CITY OF KIRKLAND
Planning and Building Department
123 5th Avenue, Kirkland, WA 98033
425.587.3600 ~ www.kirklandwa.gov

To: Design Review Board
From: Jennifer Anderer, Associate Planner
Date: February 6, 2023
File No.: DRV22-00407
Subject: **THE FOUNDRY
CONCEPTUAL DESIGN CONFERENCE**

THE FOUNDRY at Totem Lake

Conceptual Design Conference

MINOR MODIFICATION REQUEST 1 | REMOVAL OF 15' LANDSCAPE BUFFER

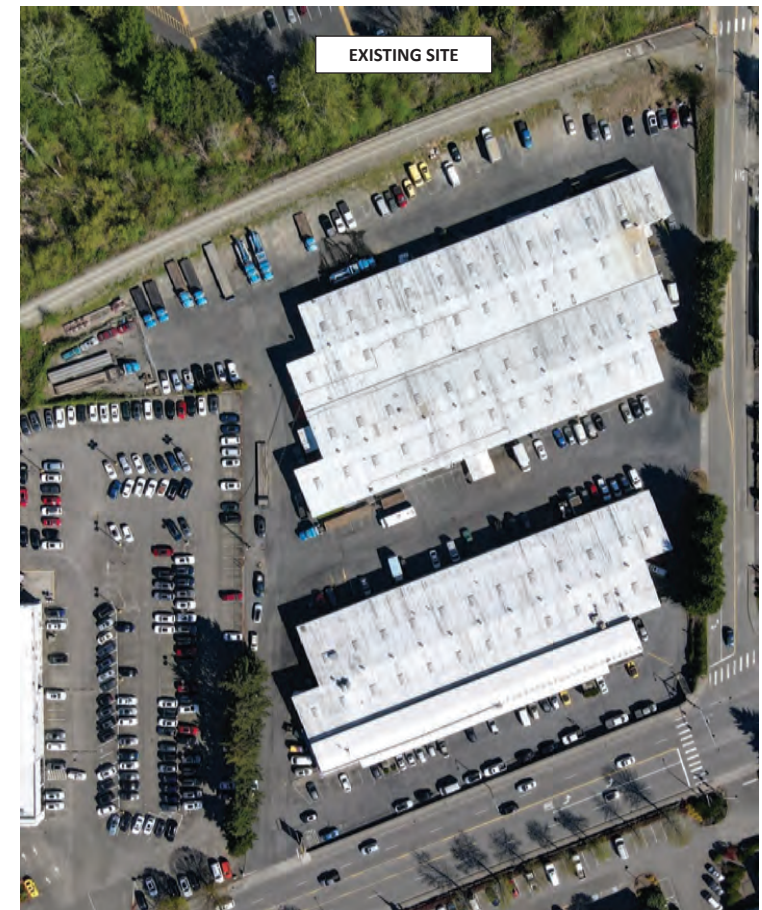
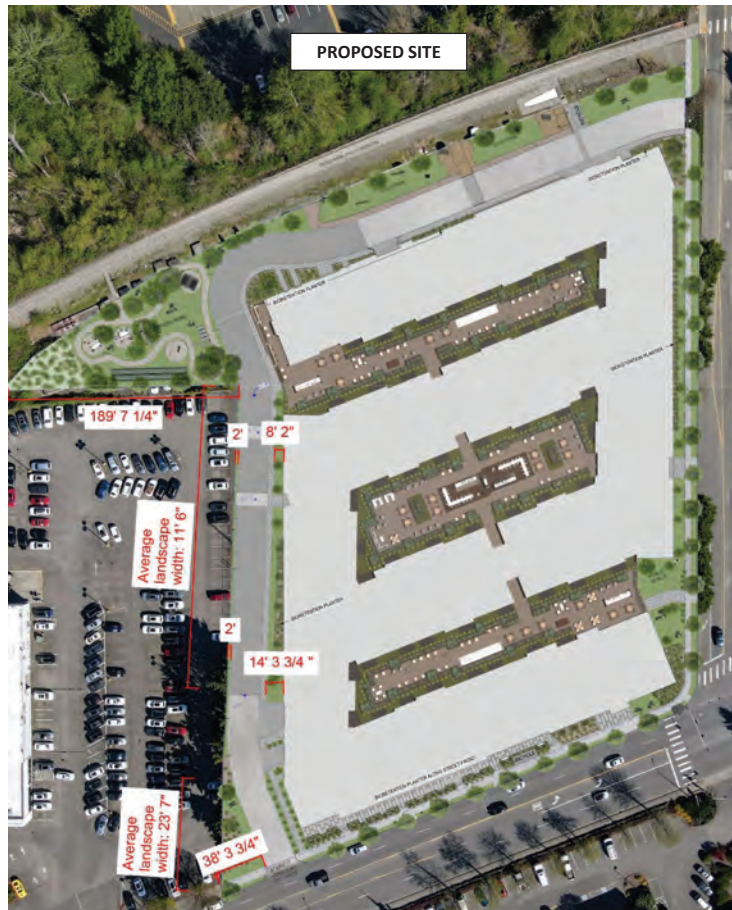
Staff Comments: The conceptual plans do not comply with the landscape buffer requirements as proposed. Staff recommends that the applicant revise the design to comply with the landscape buffer requirements. If a modification is requested, the applicant must submit a design that complies with the modification criteria and specifically addresses the modification criteria for each landscape buffer requesting a minor variation from the landscape buffer 1 standards. The applicant will be required to demonstrate compliance with applicable City landscape buffer requirements during the Design Response phase. At the Conceptual Design Conference, the Design Board should provide design guidance and identify any required submittal materials that the applicant should include in the Design Response Conference application.

Permit the landscaping buffer on the West side of the property as designed. Due to the shape of the lot, some areas are yield less than 15' of landscaping.

This departure results in a superior design and has a substantial public benefit. Granting this departure results in improved setbacks from the adjoining property and achieves the City's intent for this design guideline.

Per KZC 95.42.1, a 15 foot landscape buffer is required along adjacent properties. Only our Western property line abuts another property, currently the Volkswagen dealership. Along this property line are several differing elevations which act like a fence and buffer themselves. Between our property line and our building's West façade we are providing a semi-pervious publicly accessible road, and semi pervious pedestrian pathway which allow pedestrian and vehicular access to the CKC, the fitness park, the dog park, and the parking garage entrances. This drive aisle also serves as Fire Department access to the West and South sides of the building. Our design provides a significant buffer between the adjacent property. When not including the fitness park we are averaging 17' 6" of landscaping on the West side of the property. This is over and above the 24' semi pervious drive aisle and 5' pedestrian walkway on this side of the property. Our total landscaping and buffer far exceeds the 15' required by the City. All landscaped areas on this side of the property will be landscaped according to the Type 1 landscape standards in KZC 95.42.1.
